Since February 1974 injection valves are installed with double sealing edge connection:

Modified injection valve

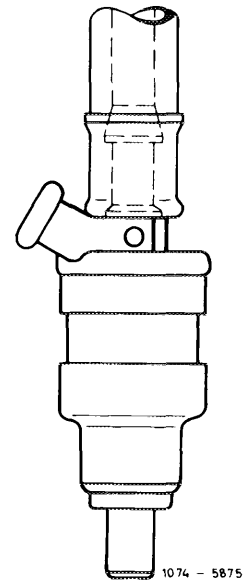
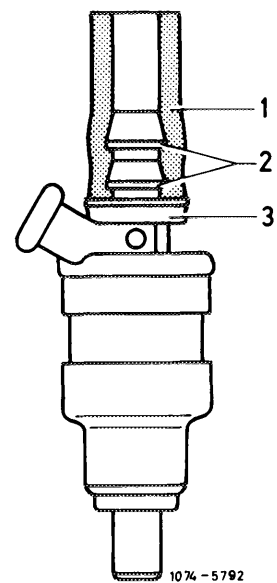
Former injection valve
Hose sleeve: height 17 mm

For manufacturing reasons, only the injection valve with double sealing edge connection is installed.

The fuel hose of the injection valve is attached to ring line by means of hose clip part no. 001 997 69 20.

There is no hose clip on injection valve itself.

- 1 Fuel hose
- 2 Double sealing edge connection
- 3 Hose sleeve (yellow):
height approx. 5 mm
